10th June 2021

We are responding to your invitation for comments on an application before you for referral to the Expert Panel under the COVID-19 Response (Fast Track Consenting) Act 2020 (FTCA).

The application is made by Urban Resort Limited and Icon Co Pty (NZ) Limited and is located at 224 Great South Road and 53, 53A, 49-51 Omahu Road, Remuera (Lot 1 DP 146628, Lot 4 Deeds Reg 308, Lot 5 Deeds Reg 308, Lot 2 DP 53665, Lot 3 DP 53665 and Lot 2 DP 146628).

Specialist Response - Planner

GIS screenshot showing the watermain line to be upsized/upgraded to 200mm.

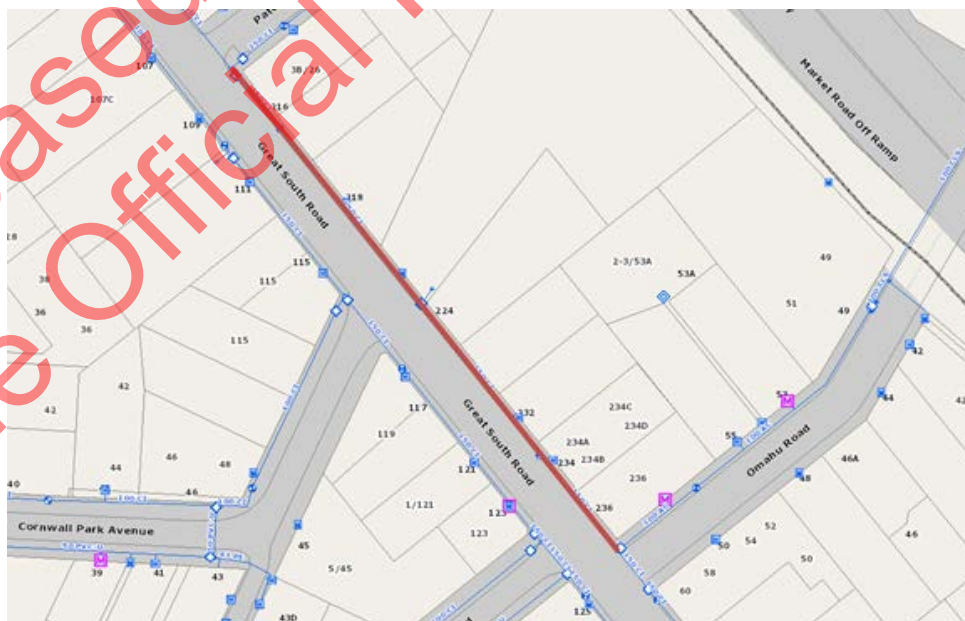
The existing 150mm CI watermain along the eastern side of Great South Road does not have capacity. It will need to be replaced with a new 200mm ID watermain and all current connections transferred from the 150mm to the new 200mm watermain.
